Sheet: /		
File: NR23_Schematic_v1.0.kicad_sch		
Title:		
Size: A	Date: 2023-03-03	Rev:
KiCad E.D.A. kicad (6.0.10)		Id: 1/7

Car Tractive System

Benchtop Model

Sheet: /Driver Interface/ File: DriverInterface.kicad_sch		
Title:		
Size: A	Date: 2023-03-03	Rev:
KiCad E.D.A. kicad (6.0.10)		Id: 3/7

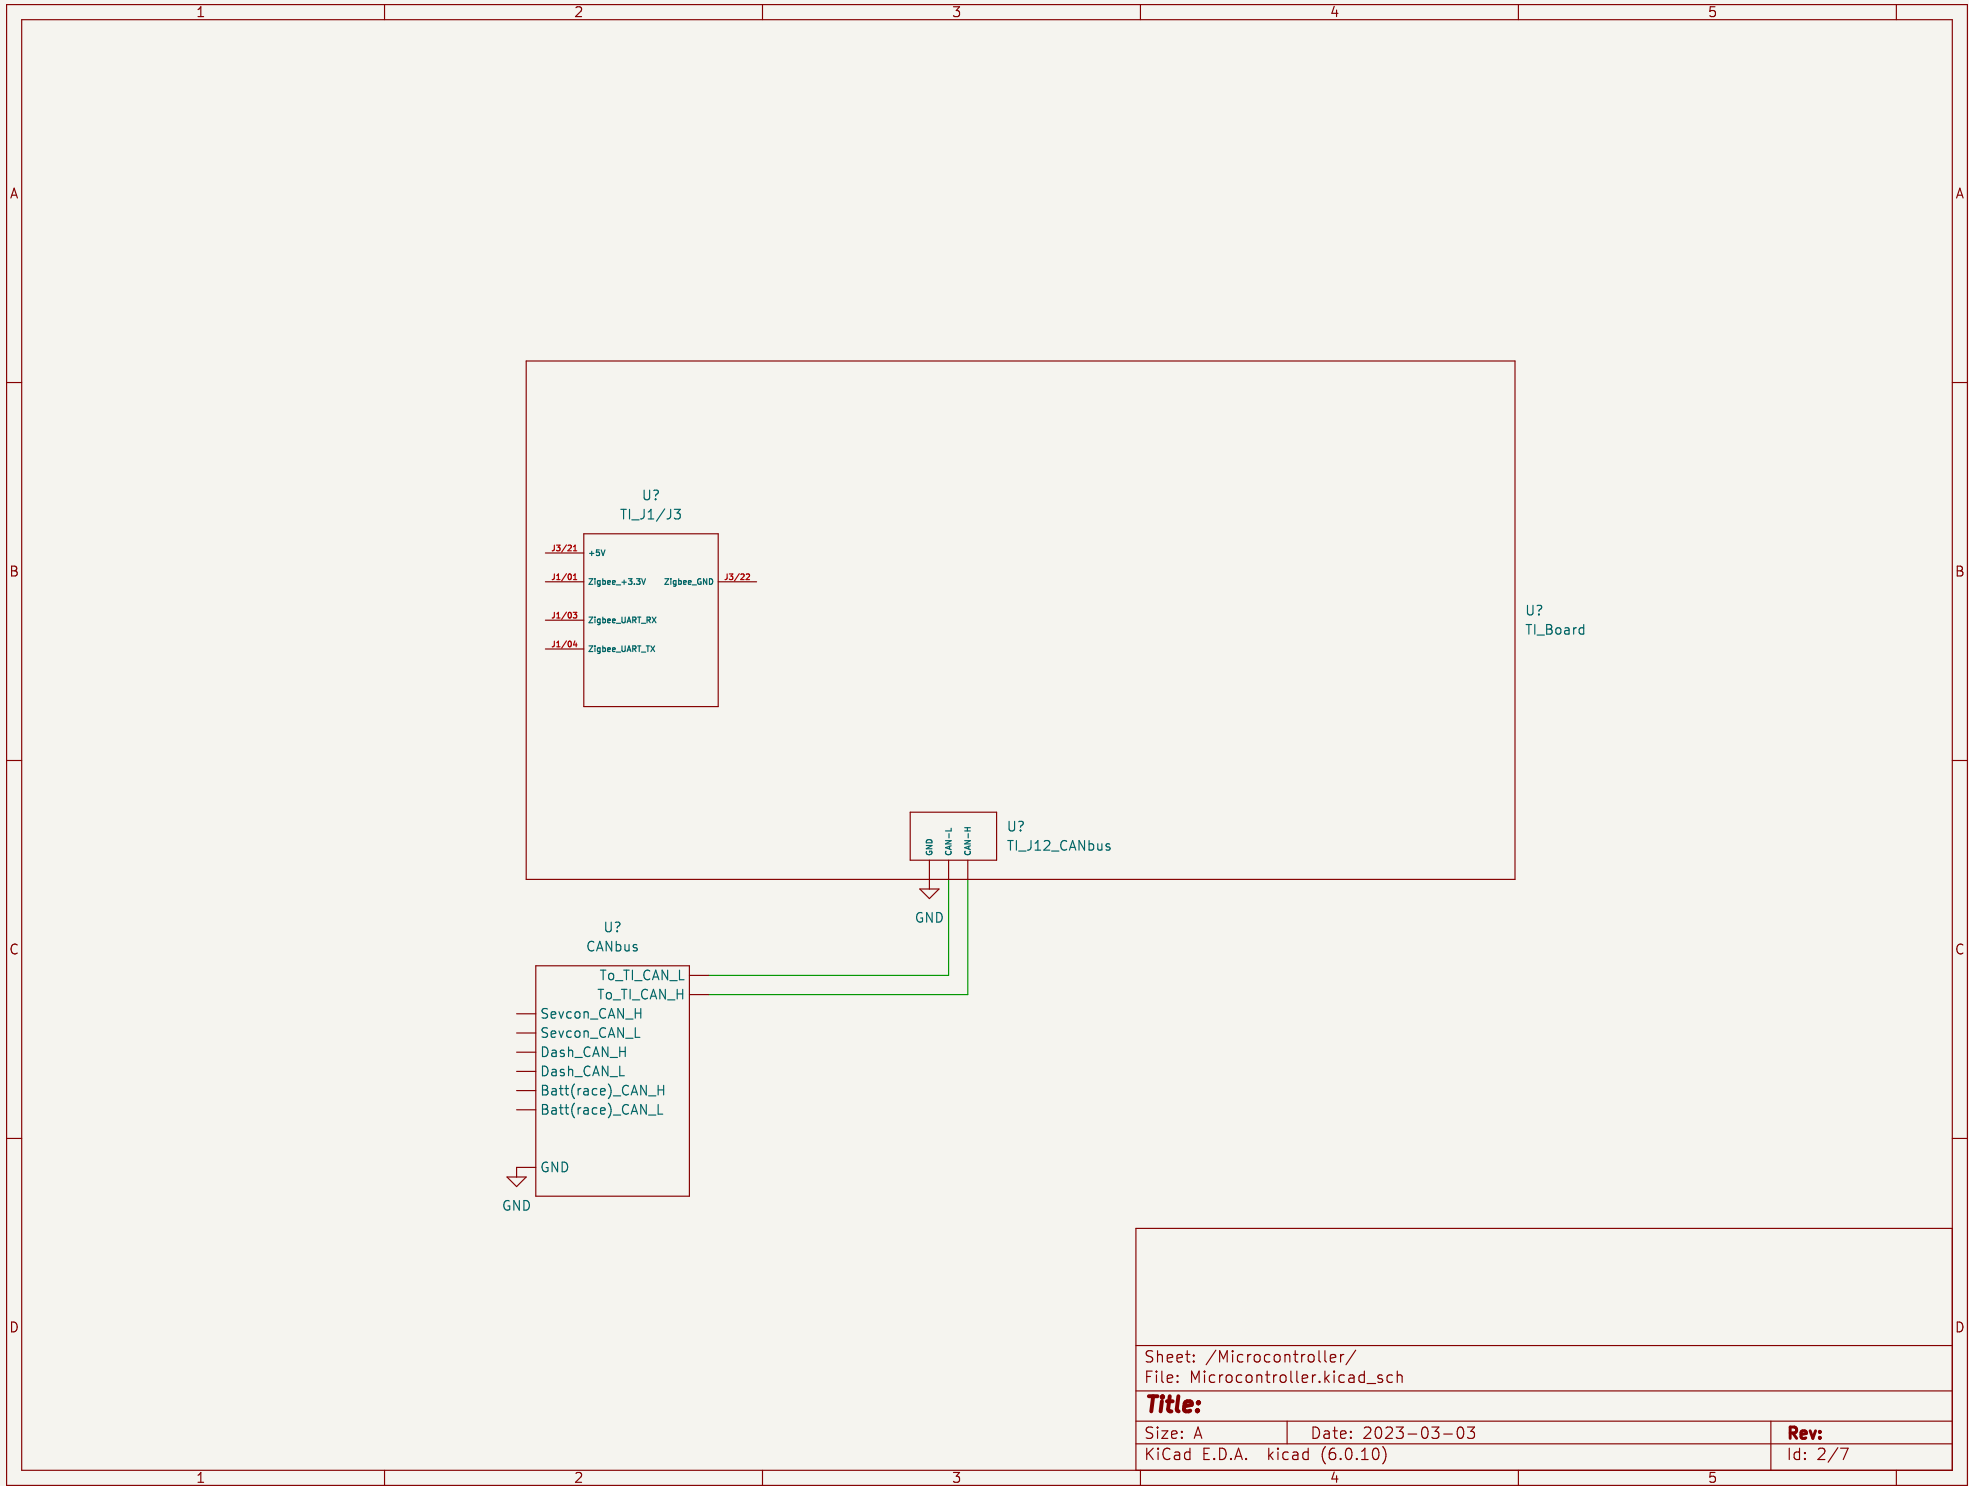
The throttle pedal is now inside the tractive system schematic

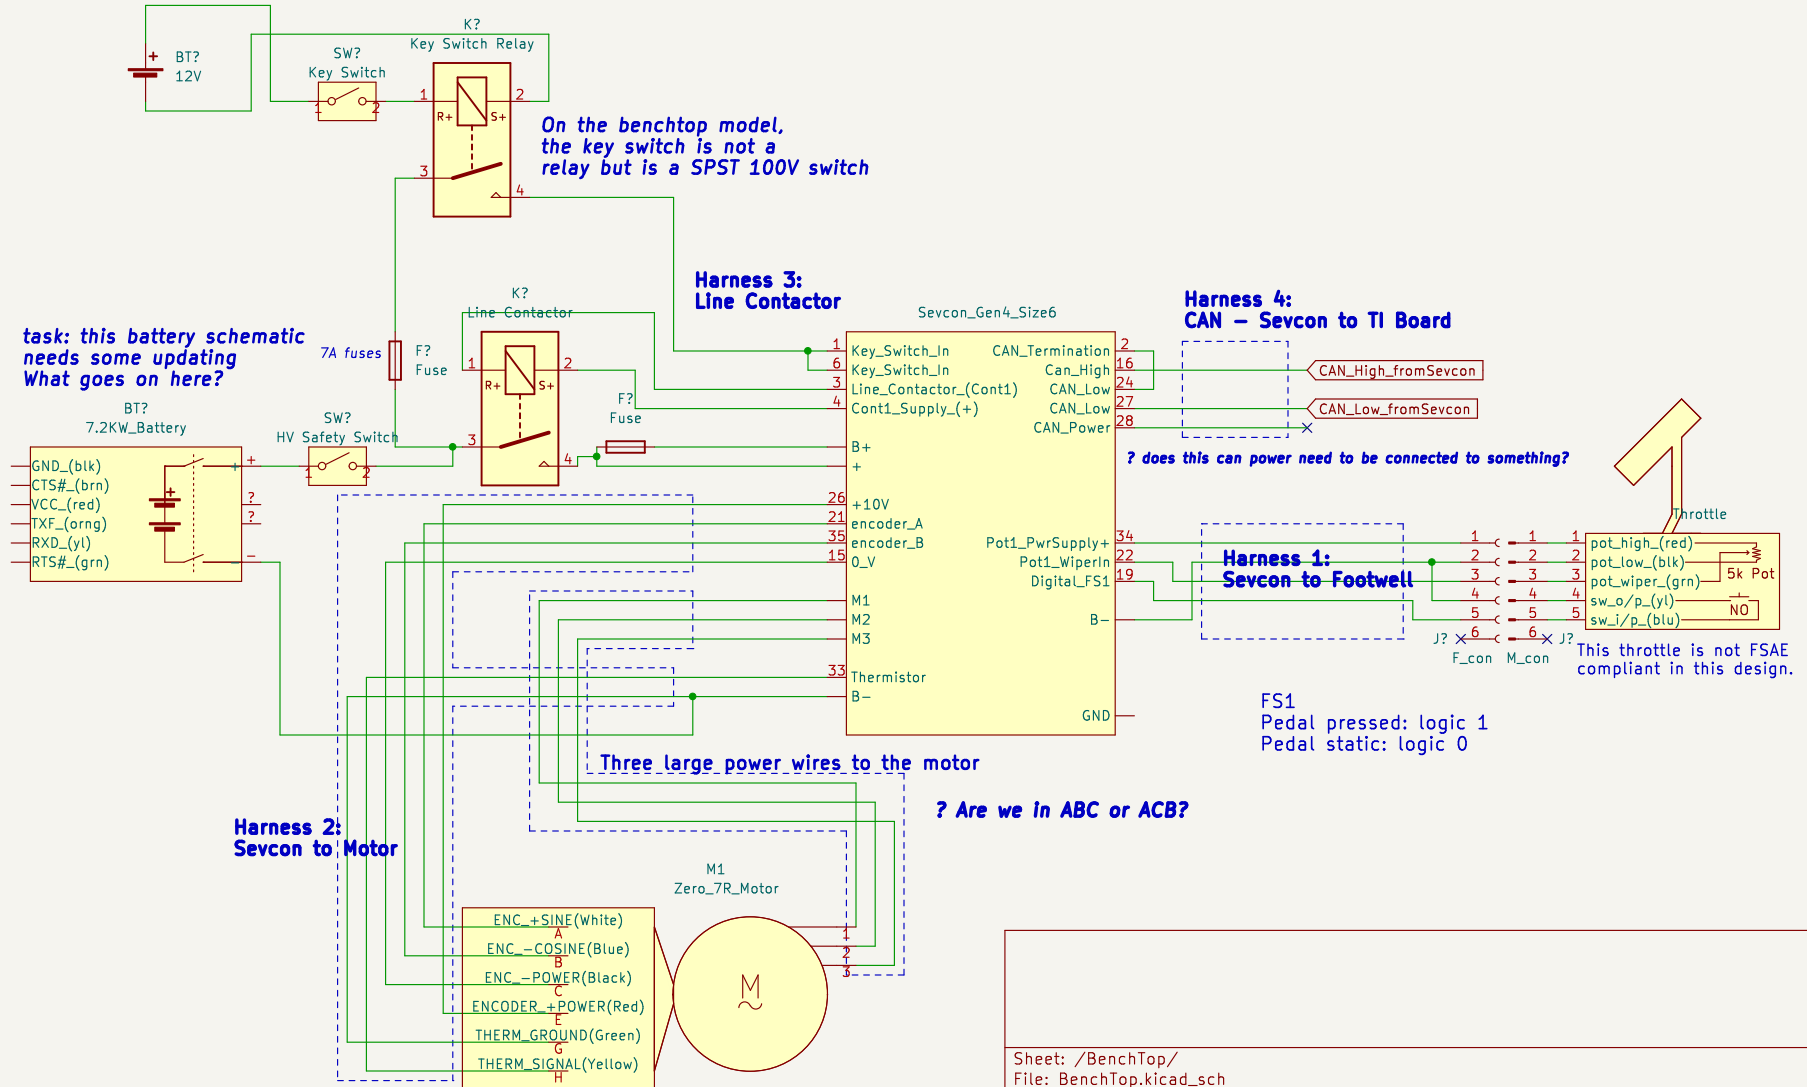
task: this battery schematic needs some updating
What goes on here?

? does this can power need to be connected to something?

This throttle is not FSAE compliant in this design.

? Are we in ABC or ACB?
